# Product Note

## LPCXpresso1769/CD rev D

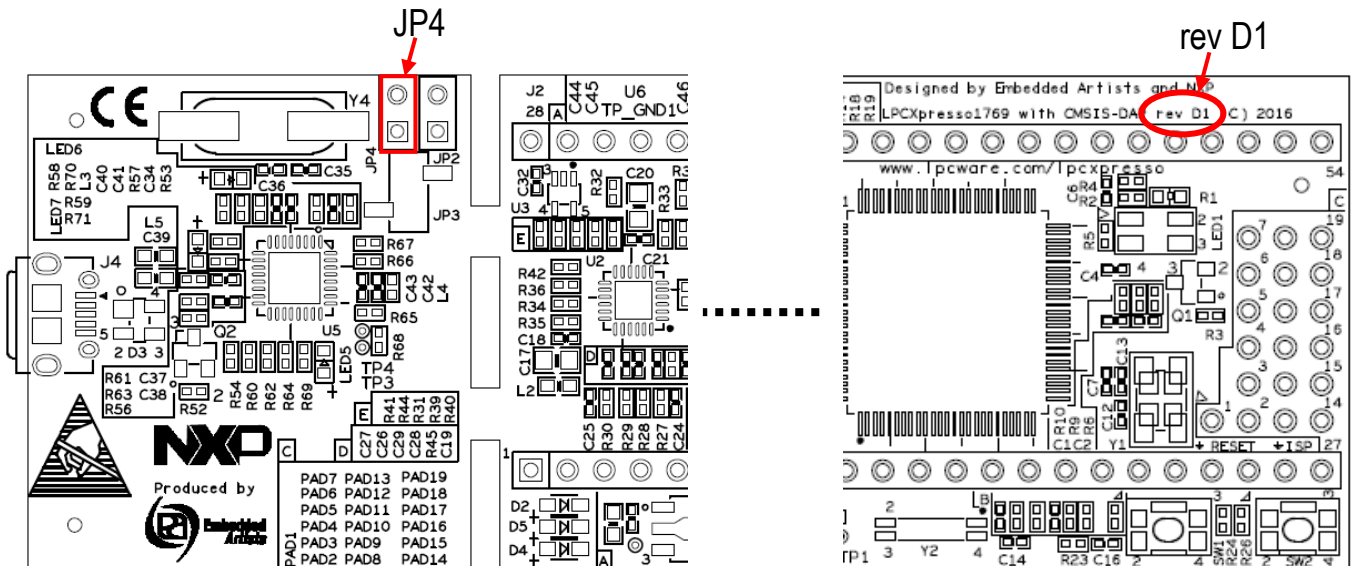
**Note that rev D1 boards are not affected.** See picture below for location revision text. R57 is not mounted on this revision.

If debugger firmware ever needs to be updated on rev D1 boards, the procedure is the following:

1. The board should be standalone, i.e., not mounted on a base board.
2. Short the two positions in JP4, for example with a wire.
3. Power up the board by inserting the USB cable in J4.
4. Observe the "CRP DISABLD" drive appearing on the PC.
5. Delete the file "firmware.bin" from the "CRP DISABLD" drive.
6. Copy the new debugger firmware to the "CRP DISABLD" drive.
7. Remove the short in JP4.
